APPENDIX B: OCTOBER 2016 ADEQ RESPONSE TO EPA COMMENTS

October 12, 2016

Subject: EPA's Modeling Protocol Feedback for Independence County, Arkansas
(Entergy Independence Power Plant & FutureFuel Chemical Company Combined SO₂
NAAQS Demonstration)

Figure 1: Wind Speed and Wind Direction Frequency for 2012-2014 for the Little Rock Airport / Adams Field

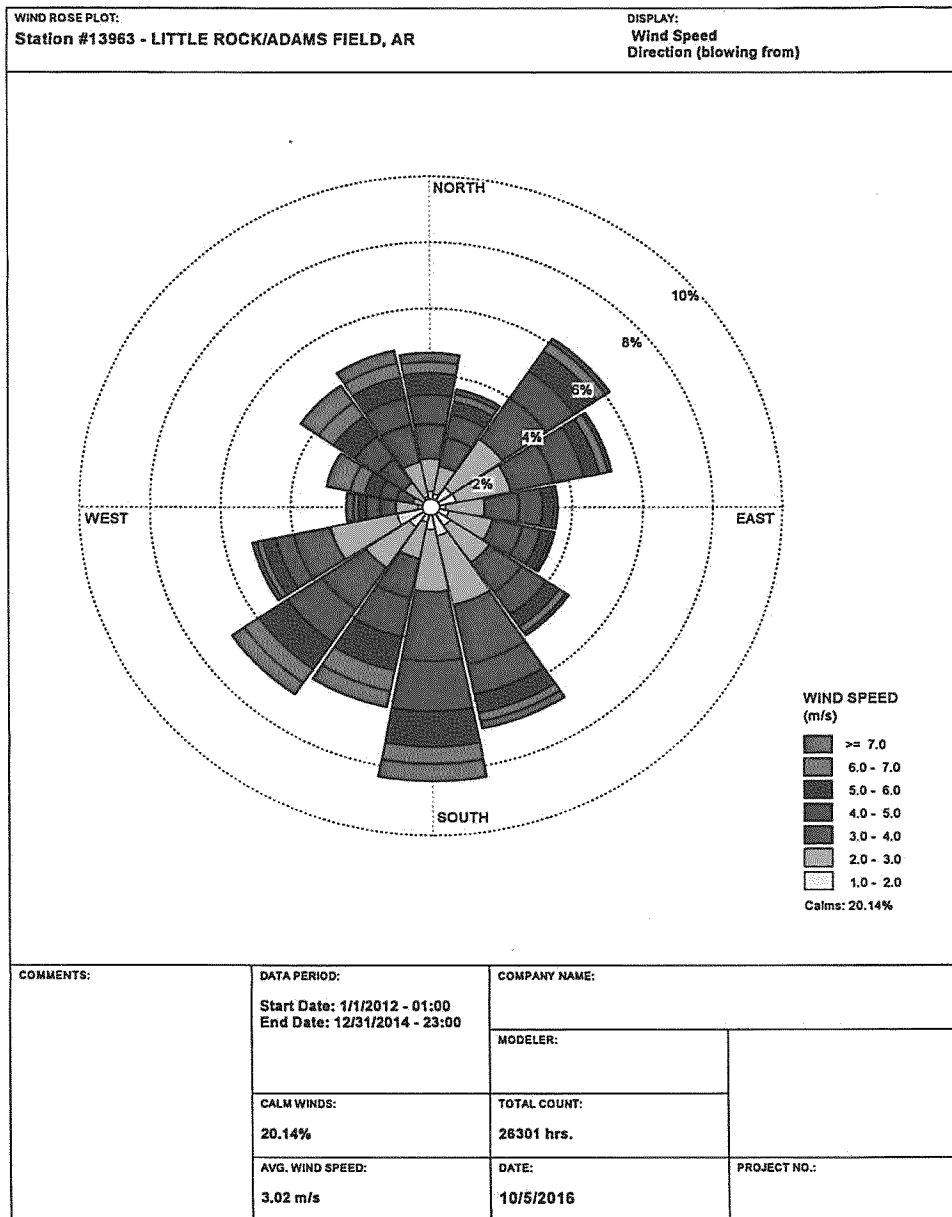
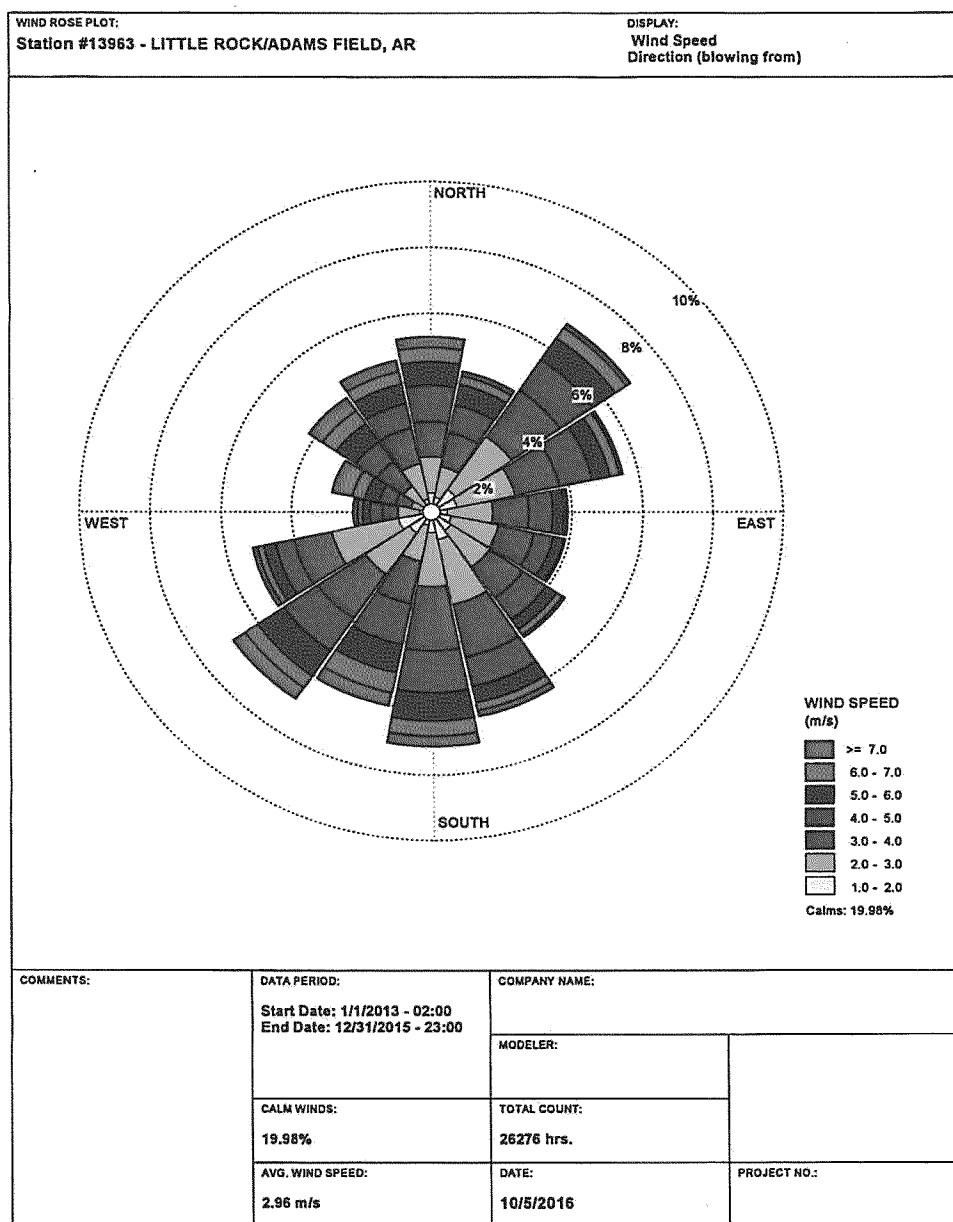
EPA General Comment 1 – “The protocol indicates that meteorological data, background concentrations, and emissions information for 2012-2014 will be used in the analysis. If available, we suggest conducting the modeling with the latest 3 years of data (2013-2015). If the data period is not updated, we request that information be provided to support that the 2012-2014 data period is representative of the most recent 3 year period.”

1) Meteorological Data: For the Little Rock Airport (the source of Meteorological data inputs), the distribution of wind speed and direction is nearly identical for both three-year periods. There is a slightly greater proportion of southerly winds (from the south) for 2012-2014 (Figure 1) compared with the later overlapping three-year period and a slightly greater proportion of northeasterly winds for 2013-2015 (Figure 2) compared to the prior overlapping three-year period. In both cases, the average wind speed is approximately 3 meters per second (m/s) and winds are calm approximately 20 percent of the time.
